Re: FC-8476, Installation of Traffic Calming Devices

Addendum No.1

ADDENDUM NO. 1

Figure 2

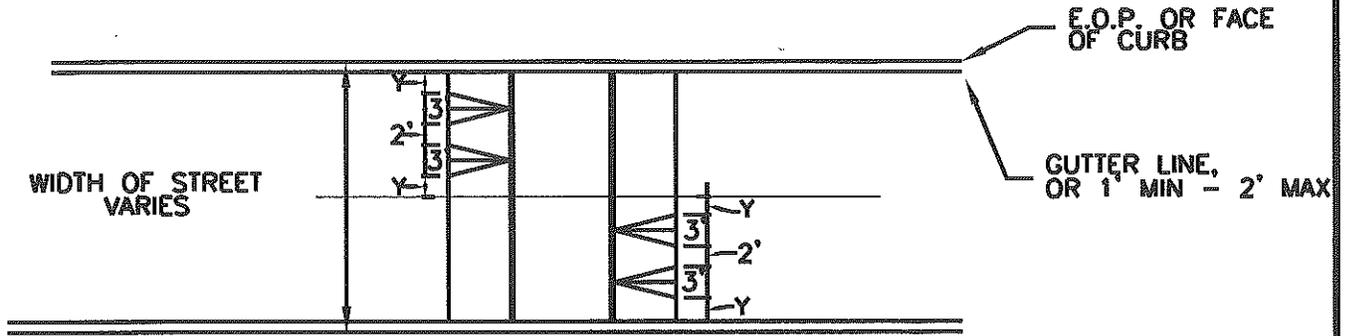
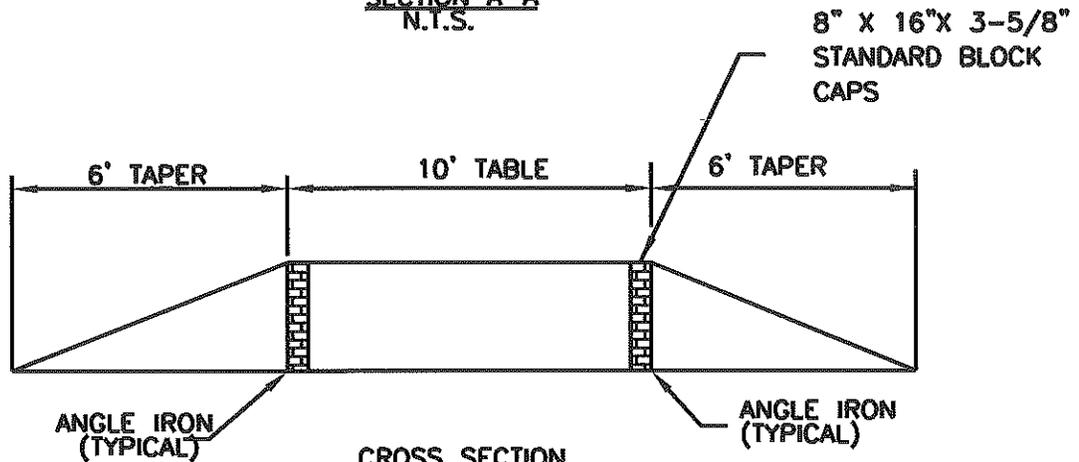
Per Specification's Section item 2.7 *"The Contractor shall install four (4) preformed thermoplastic, hot tape "shark teeth" two (2) in each direction of travel. They shall have a '3 base and be 5' tall and 125 mill thick, ester rosin, pre-beaded and retro-reflective (Fig. 2). There is no figure 2 to go along with the directions.*

Answer: Figure 2 is attached.
